Product Change Notification PCN_BUR_00205

Subject: Eaton Bussmann® TMF Red spot fuses - new dimensions

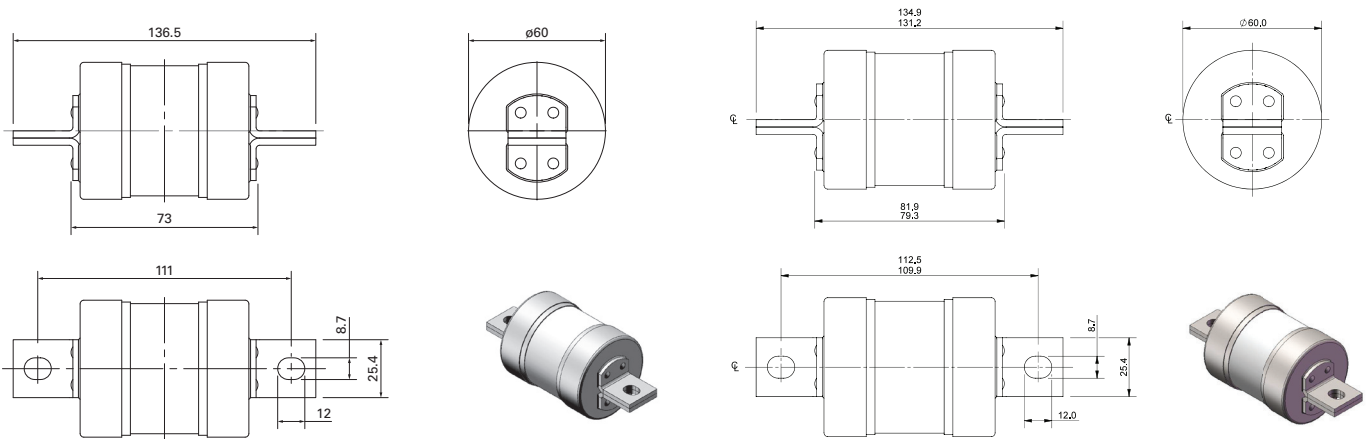
Please be informed that the dimensions of the Eaton's Bussmann series TMF red spot fuses have been updated, with immediate effect. The outline drawings below shows the previous and new dimensions for your reference.
